Re Garvies Point Waterfront Mixed-Use Development
Second Amended PUD Master Development Plan and
Phase IIB D-E-F Site Plan
March 2021 Submittals

This letter has been prepared to address the review memo dated April 27, 2021 from Mr. Robert G. Nelson, Jr., P.E. of Nelson + Pope (N+P No: 15122). Please note that the order of our responses follows the order of the original comments, and we have included the original comment followed by our response in ***bold italics***.

G1 - Garage Plan

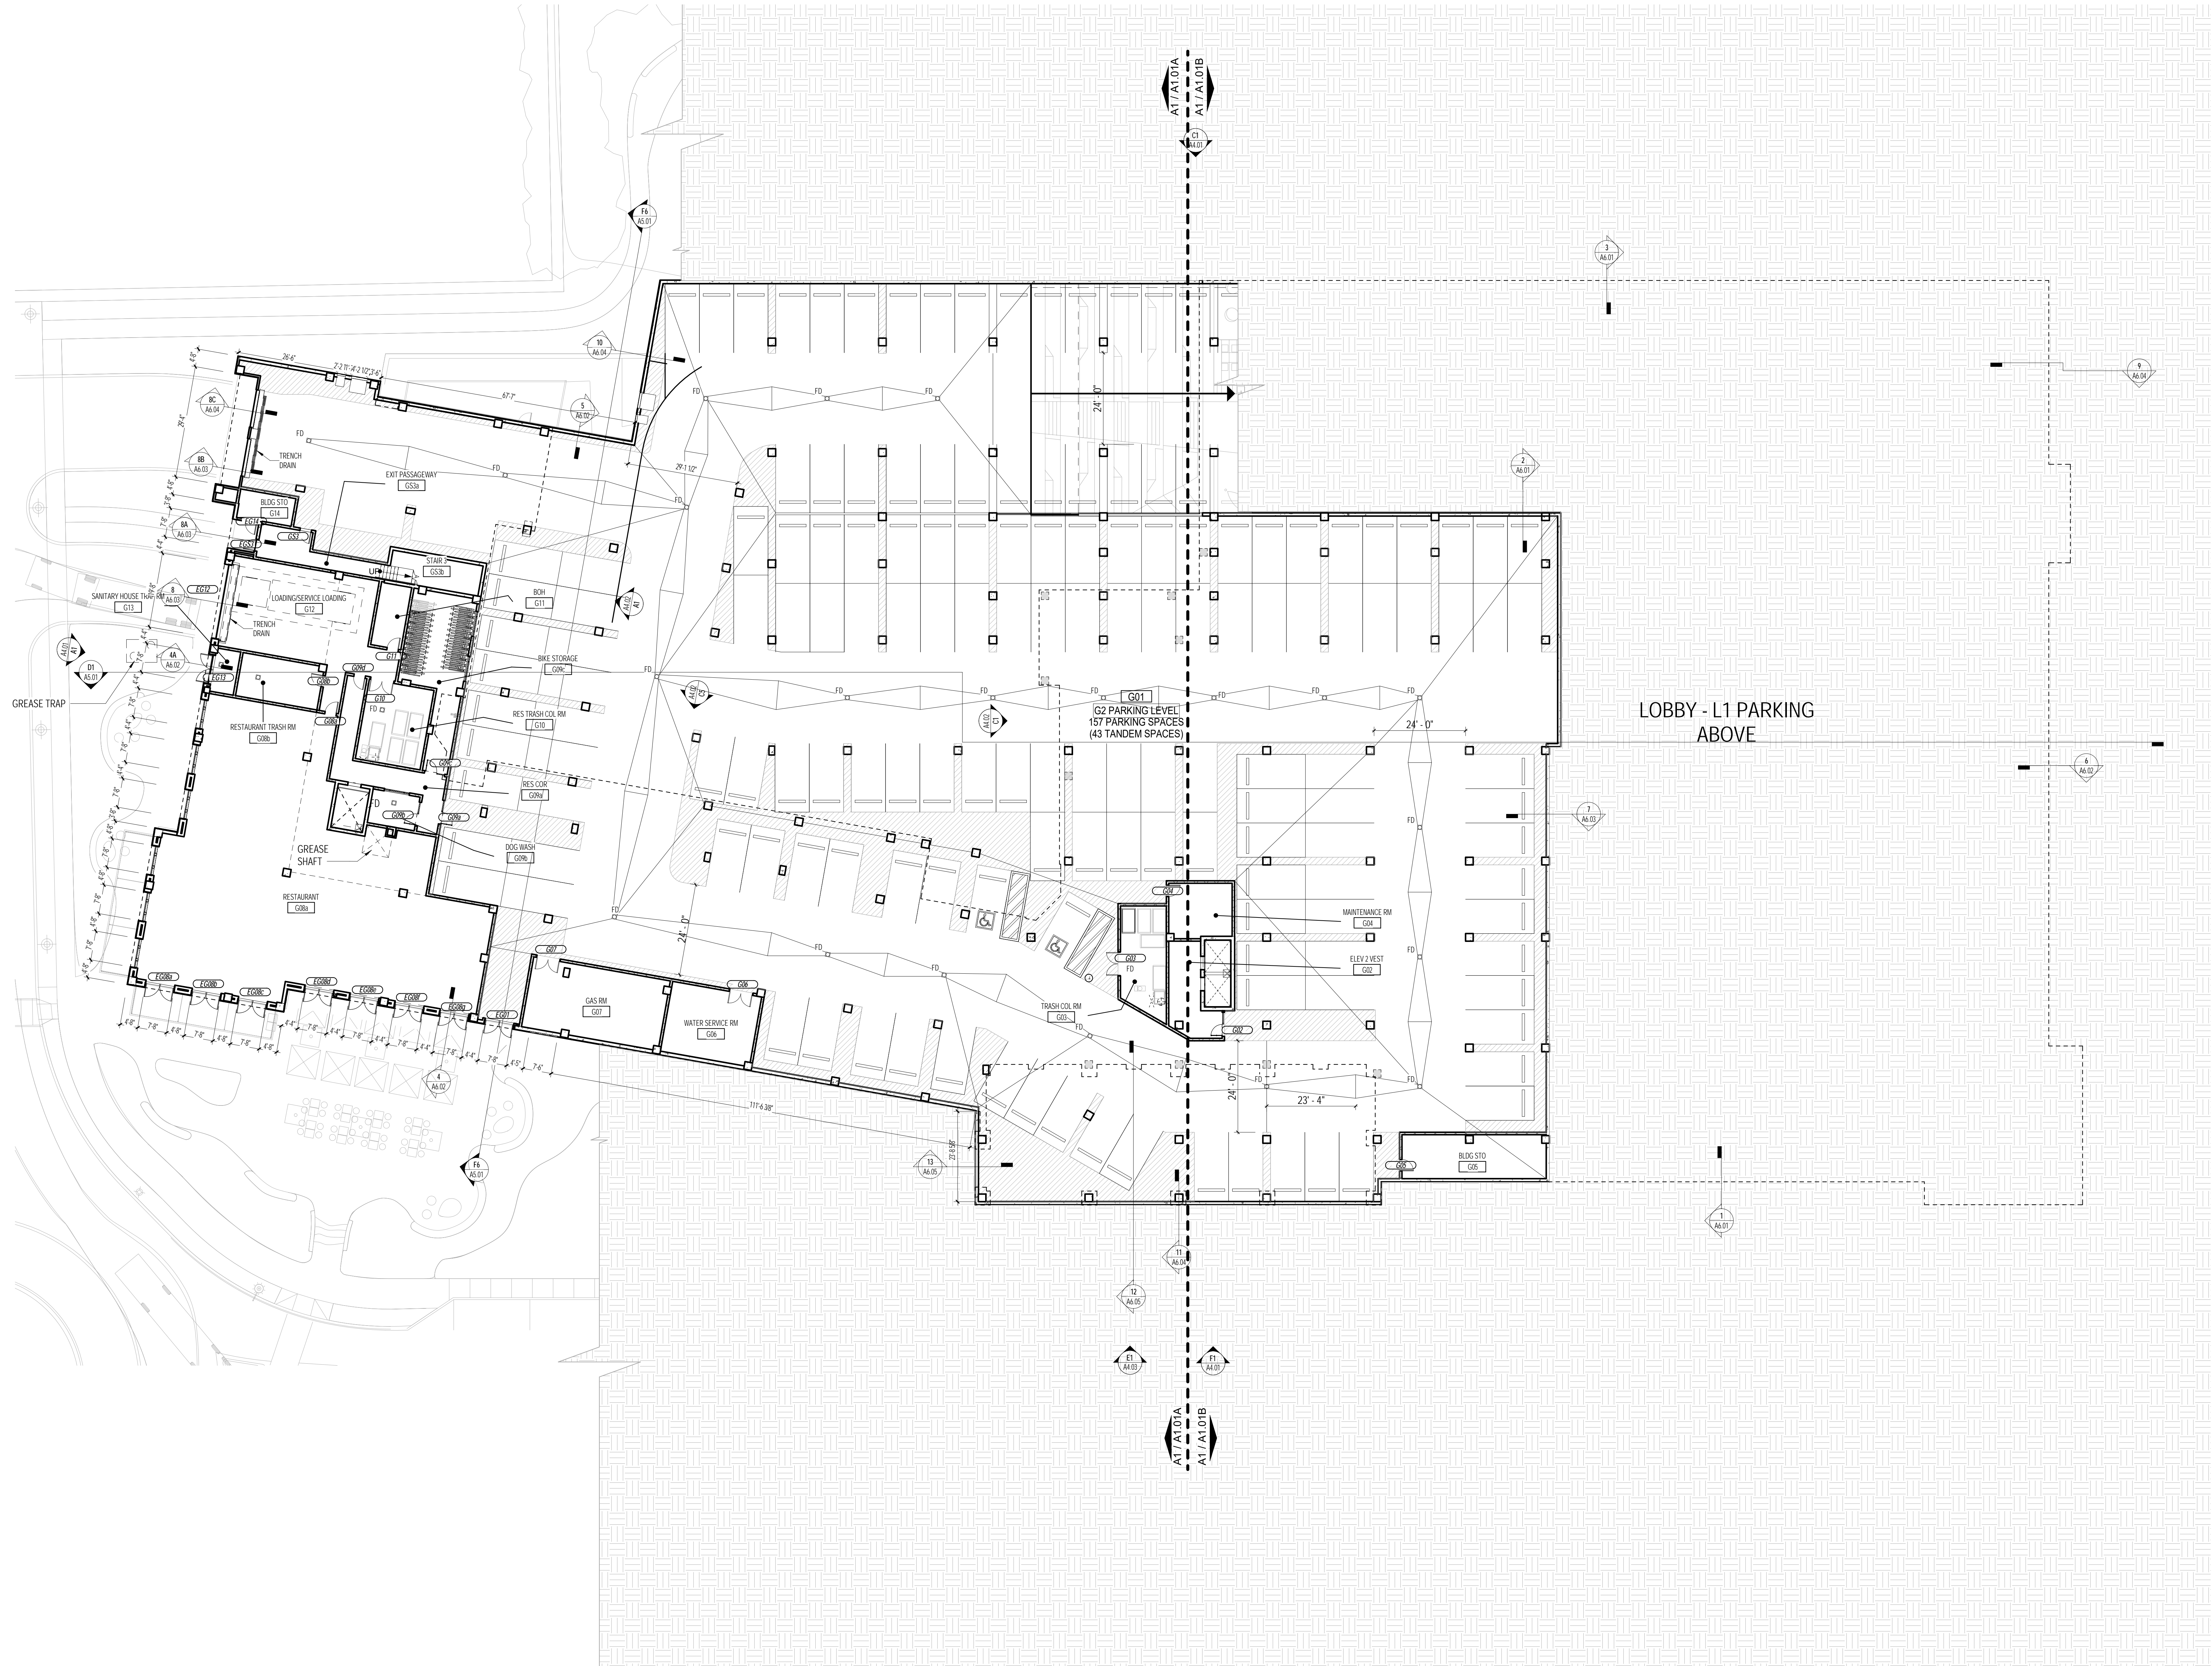
- e. Interior parking plan for the Blk. E/F should be provided to confirm the number of stall provided in the garage.

RESPONSE: The interior parking plan for Blk. E/F was included in the Architectural Set submitted in December; those pages are appended for reference.
